The Commission has issued the enclosed Amendments Nos. 111, 111, and 108 for Licenses Nos. DPR-38, DPR-47 and DPR-55 for the Oconee Nuclear Station, Units Nos. 1, 2 and 3. These amendments consist of changes to the Station's common Technical Specifications (TSs) in response to your request dated November 13, 1981, as supplemented by letter dated March 24, 1982.

These amendments revise the TSs to support full power operation of Oconee Unit 2 during fuel Cycle 6.

SAFETY EVALUATION BY THE OFFICE OF NUCLEAR REACTOR REGULATION
SUPPORTING AMENDMENT NO. 111 TO FACILITY OPERATING LICENSE NO. DPR-38
AMENDMENT NO. 111 TO FACILITY OPERATING LICENSE NO. DPR-47
AMENDMENT NO. 108 TO FACILITY OPERATING LICENSE NO. DPR-55
DUKE POWER COMPANY
OCONEE NUCLEAR STATION, UNITS NOS. 1, 2 AND 3
DOCKETS NOS. 50-269, 50-270 AND 50-287

CORE PROTECTION SAFETY LIMITS
 UNIT 2
 OCONEE NUCLEAR STATION
 FIGURE 2.1-2B

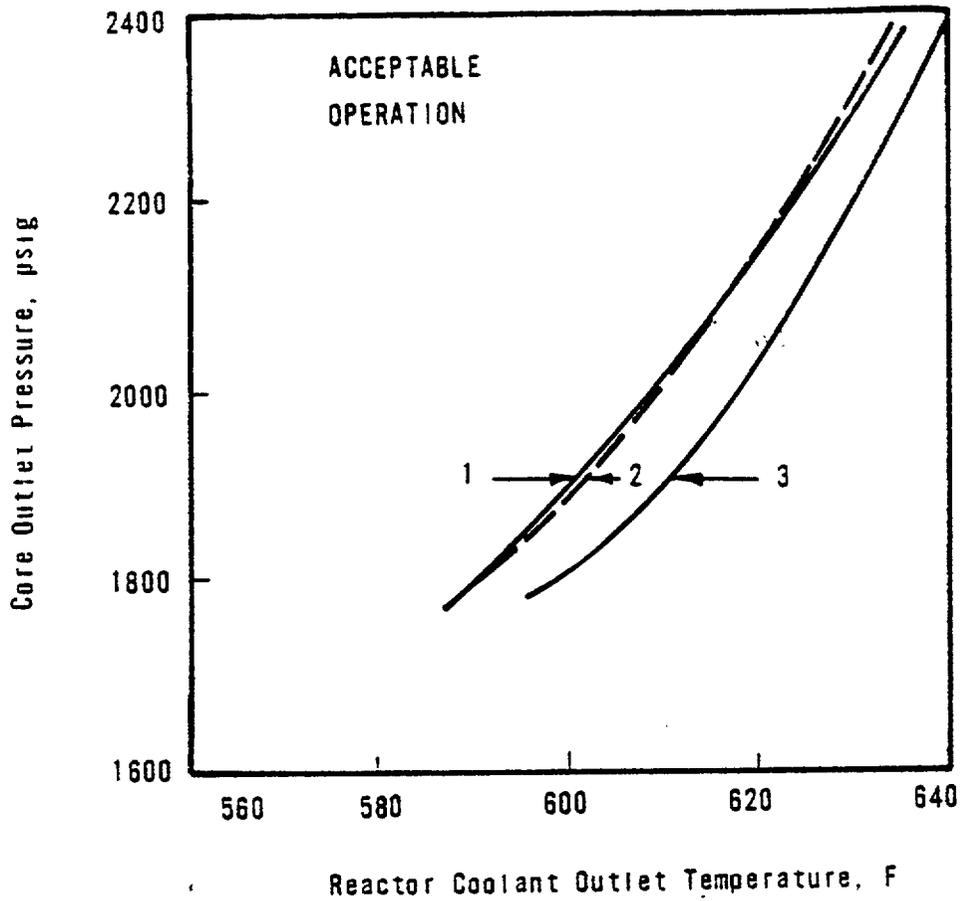
To support the operation of Oconee 2 at full power during Cycle 6, the licensee proposed modifications to core protection safety limits of TS 2.1 (Figures 2.1-2B, 2.1-3B and 2.3-2B). The changes reflect a revised flux/flow setpoint of 1.08 which remains within the safety limit DNBR criterion of 1.30 and is, therefore, acceptable.
